SALEM COUNTY IMPROVEMENT AUTHORITY

RESOLUTION No. 2021-120

**RESOLUTION OF THE SALEM COUNTY IMPROVEMENT AUTHORITY
AUTHORIZING CHANGE ORDER #4 TO THE CONTRACT
FOR CONSTRUCTION AND INSTALLATION OF
THE EXPOSED GEOMEMBRANE COVER**

To: Abbonizio Contractors, Inc. ("Contractor")
Cc: Julie Acton, Mark Swyka, Prentiss Shaw
From: Arie Kremen
Date: December 1, 2021
Subject: Request for Proposal – Liner Repairs and Stormwater Enhancements

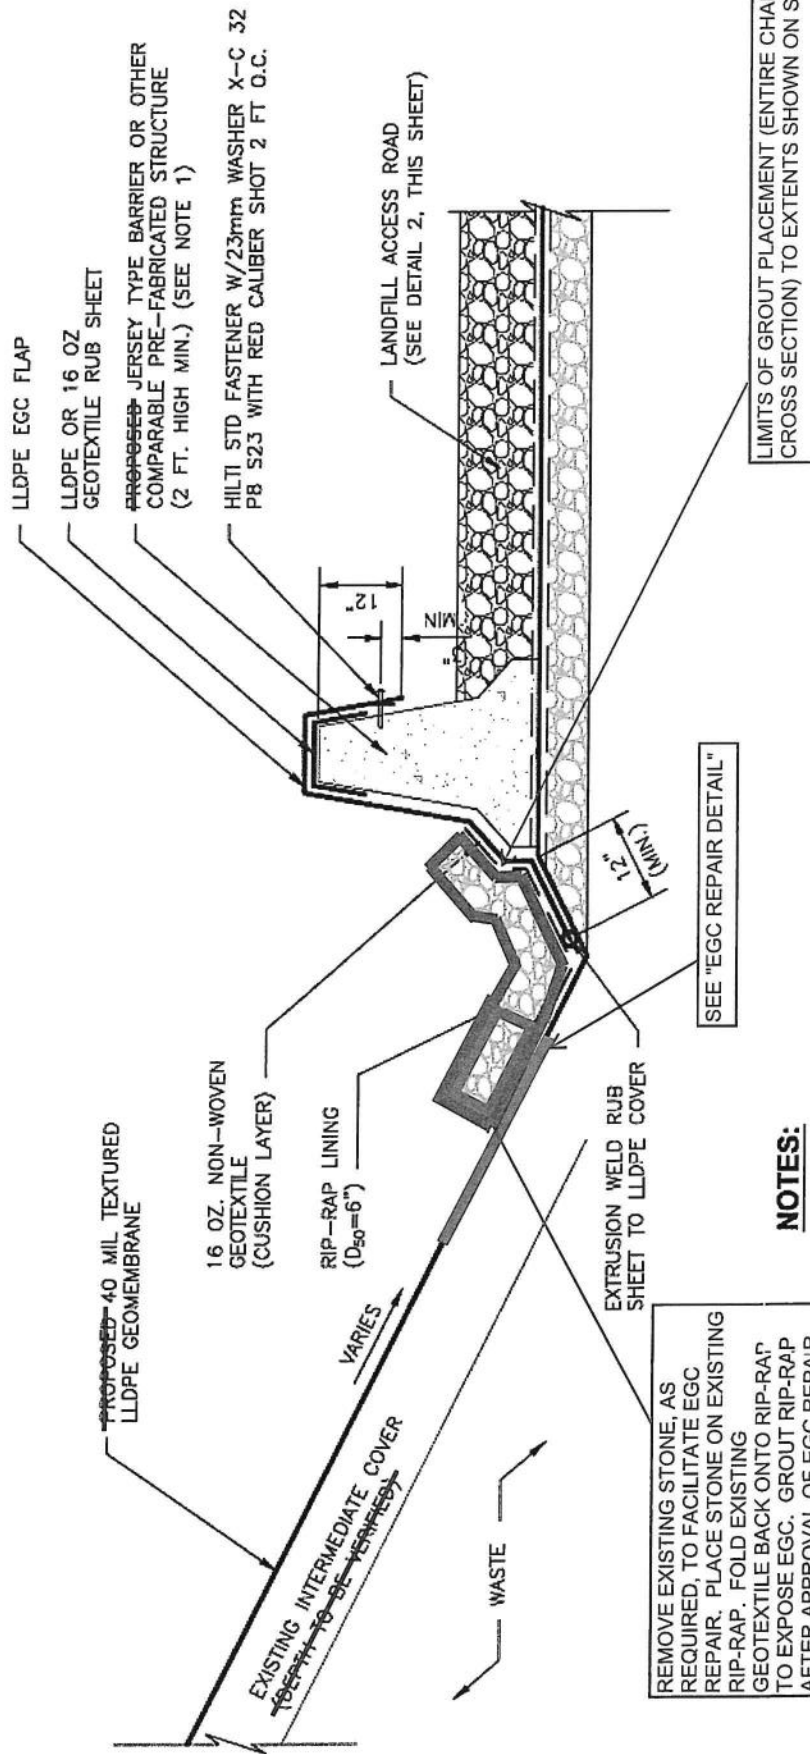
- d. Grout will be placed to the limits shown on the attached plan.
 - e. Only rip-rap placed along the existing Jersey Barrier at the Landfill Access Roadway shall be grouted.

- c. Extend the existing Jersey Barrier to the limits and lines shown on the attached plan;
 - d. Place Jersey Barriers over 16-oz geotextile, install geomembrane over top of Jersey Barrier and sheet anchors as shown Sheet No. 2;

1. JERSEY TYPE BARRIER TO BE LOCATED AS SHOWN ON SHEET-2: SITE PLAN

RIP-RAP LINED DRAINAGE SWALE AND LANDFILL ACCESS ROAD TYPICAL DETAIL SHEET NO. 2

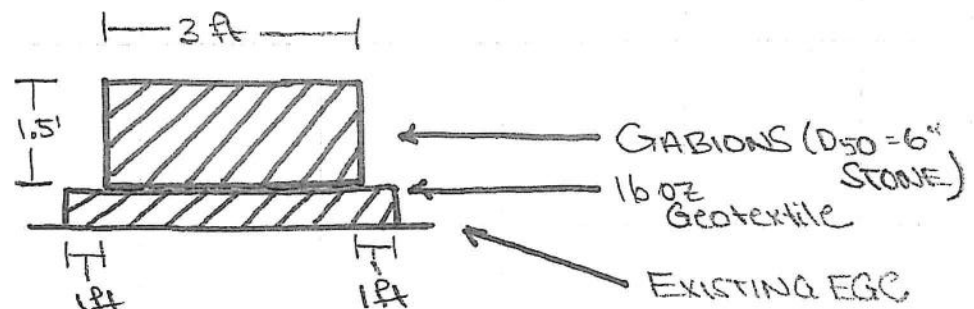
- Repair EGC (1,030 ft)
 - a. Overline existing damaged (liner with punctures along the Landfill Access Roadway) EGC with 16-oz geotextile provided by Contractor and 40-mil LLDPE "patch" (approx. 1 geomembrane panel width), remaining on site from the EGC installation, as shown on Detail Sheets No. 2 and No. 3;

- j. Schedule inspection by Engineer at least 48 hours prior to completion of repair;
- Grout Rip-rap (950 ft)
 - a. Grout rip-rap as shown on Detail Sheet No. 2 upon written acceptance of EGC Repair by Engineer;

REMOVE EXISTING STONE, AS REQUIRED, TO FACILITATE EGC REPAIR. PLACE STONE ON EXISTING RIP-RAP. FOLD EXISTING GEOTEXTILE BACK ONTO RIP-RAP TO EXPOSE EGC. GROUT RIP-RAP AFTER APPROVAL OF EGC REPAIR BY THE ENGINEER.

TYPICAL DETAIL " EGC REPAIR DETAIL "

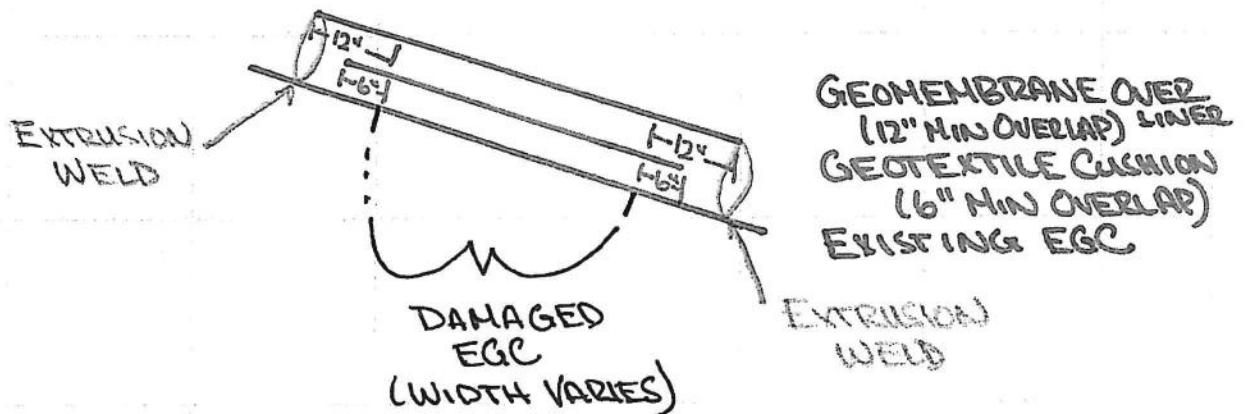
- e. No rip-rap will be placed on the swale side of the Jersey Barriers.
- Additional Gabions
 - a. Place gabions over 16-oz geotextile as shown on the attached Sheet No. 3. Gabion baskets shall be at least 18 inches tall and 3 feet wide. Gabions shall be filled with a $D_{50} = 6$ inch rip-rap stone;

- b. Gabions shall not be in direct contact with geomembrane. Geotextile shall extend at least 12 inches beyond the limits of the gabions;
 - c. Contractor shall remove rip-rap, as required, to place the gabions;

TYPICAL DETAIL " GABION PLACEMENT DETAIL "

NOTE: OVERLAPS MEASURED FROM OUTERMOST
LIMIT OF EGC DAMAGE WITHIN A REPAIRED
AREA.
